10/020,030

<b>Advisory Action</b> <b>Before the Filing of an Appeal Brief</b>	Application No.	Applicant(s)	
	10/020,030	MYERS, STEVEN DUANE	
	Examiner	Art Unit	
	Hoang-Vu A. Nguyen-Ba	2623

For: MULTI-POINT MULTI-CHANNEL DATA DISTRIBUTION SYSTEM

FIG. 1

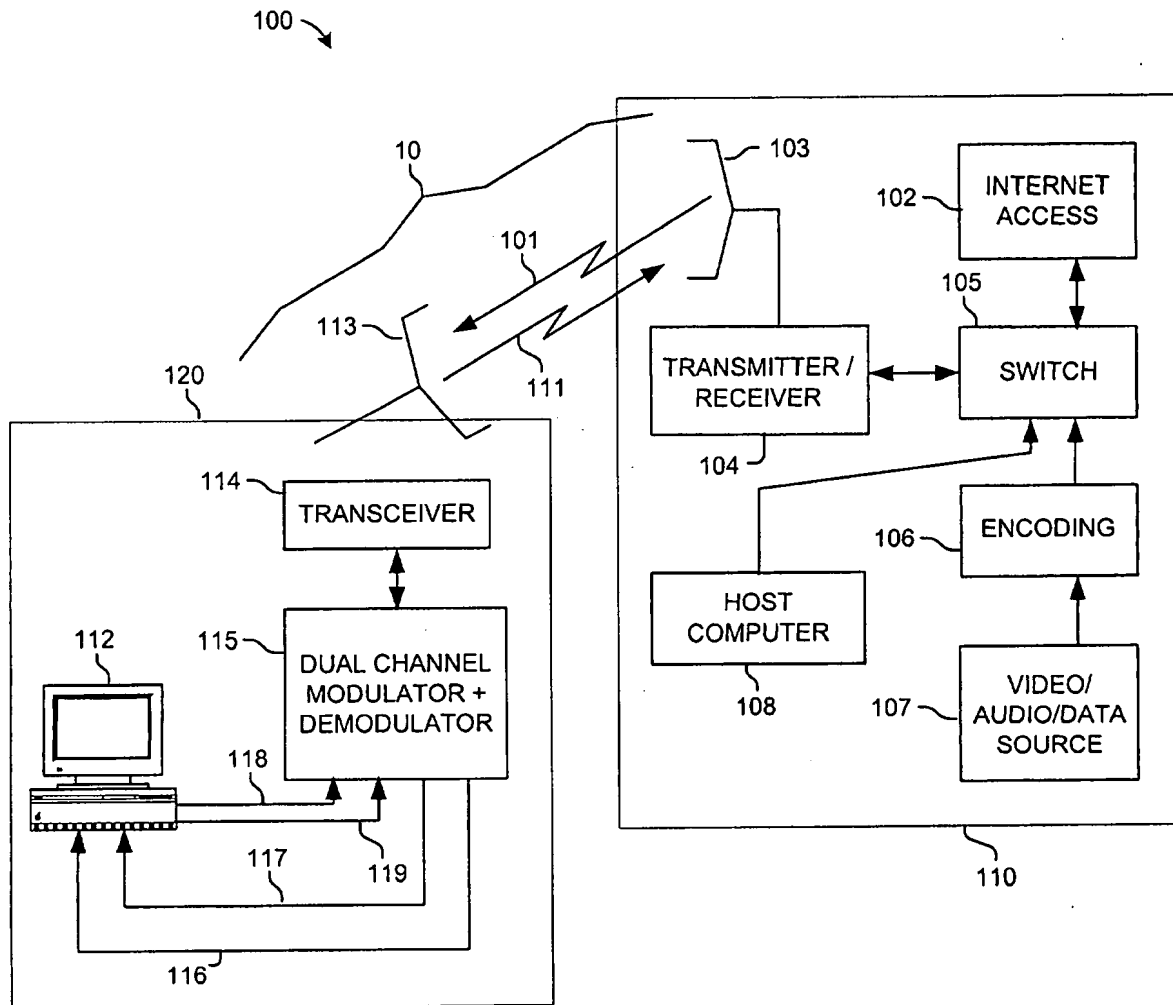
The Office action cites at least FIG. 1 as showing Station Y receiving the two signals, e.g., the bottom two input lines to device Y. Thus, contrary to Applicant's assertion Agrawal does anticipate the above features.

In response to these arguments, the examiner respectfully directs applicant's attention to FIG. 1 where it shows that the traffic received by mobile station Y (e.g., the bottom two inputs to Y) is demodulated by mobile station Y and sent to subscribers (not back to Station B as asserted by Applicant). Furthermore, these signals are multiplexed by the mobile station Y before being sent to subscribers.

For example, FIG. 1 illustrates a subscriber site 120, while FIG. 3 illustrates a subscriber unit 300. The accompanying description of FIG. 1 indicates that multiple subscriber sites are contemplated (page 5, line 20). In addition, the accompanying description of FIG. 3 indicates that subscriber unit 300 is illustrative of the type of subscriber unit that is provided at *each* subscriber site (page 9, line 23). The second subscriber unit referred to in the claims is another subscriber unit provided at another subscriber site. The illustration of subscriber unit 300 therefore adequately provides for the necessary understanding of the second subscriber unit as claimed. Regardless, multiple subscriber sites 120 (A1, A2, B1, B2, C1, and C2 in FIG. 7) are shown in the drawings.

FIG. 7

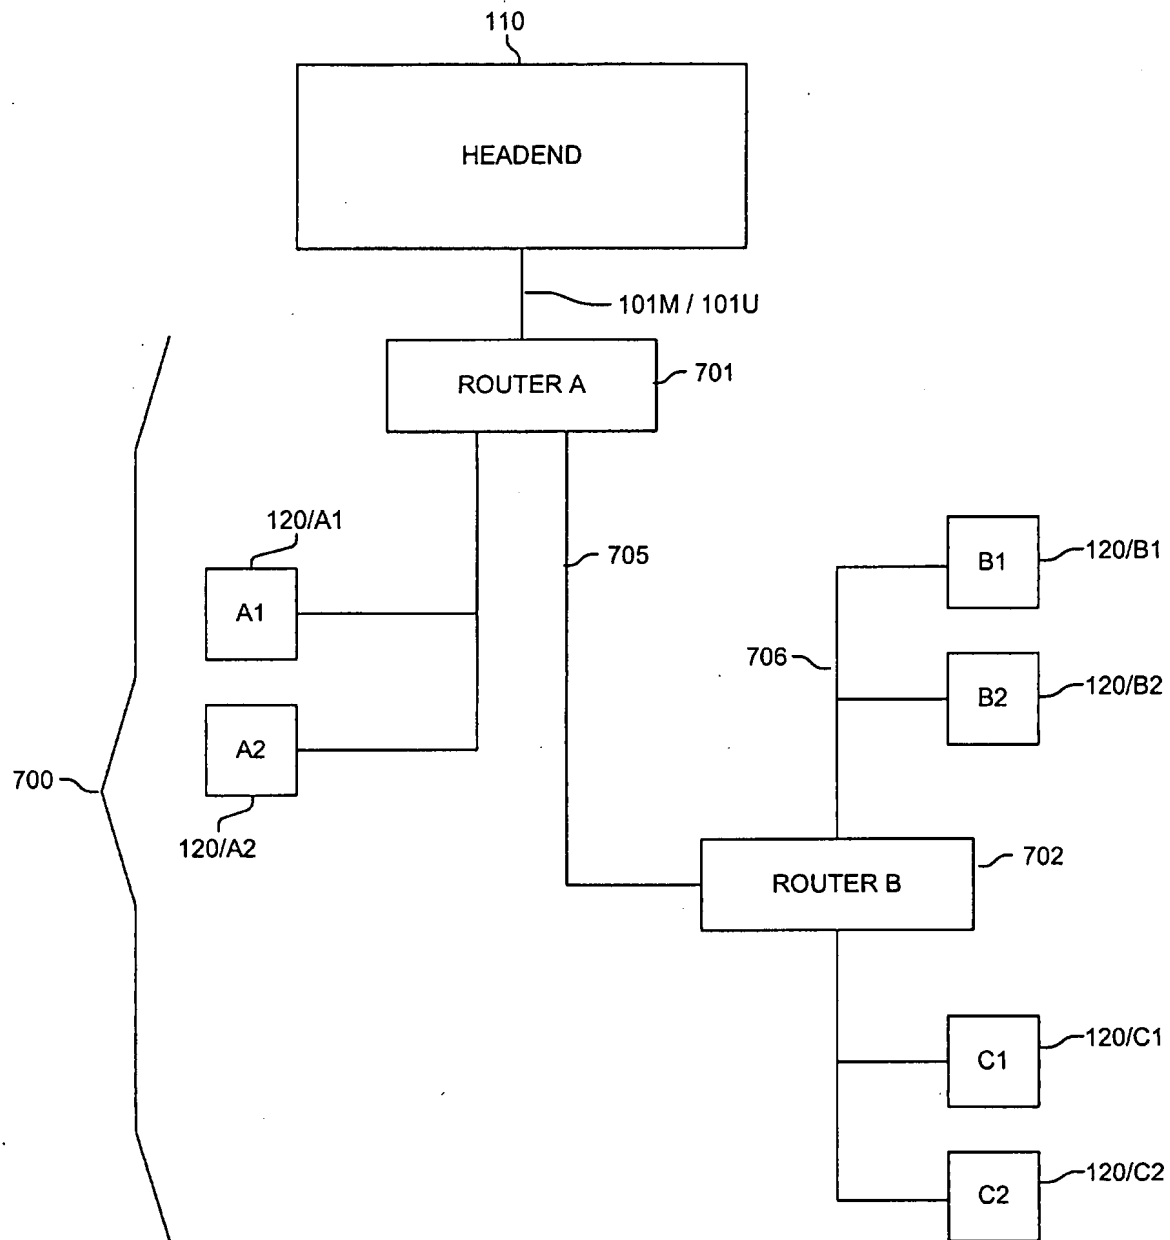
In response the examiner respectfully notes that without a written description of a second subscriber unit that is configured to receive the second CDMA signal in the specification and without an illustration of the so-claimed invention in any of the submitted drawings, the subject
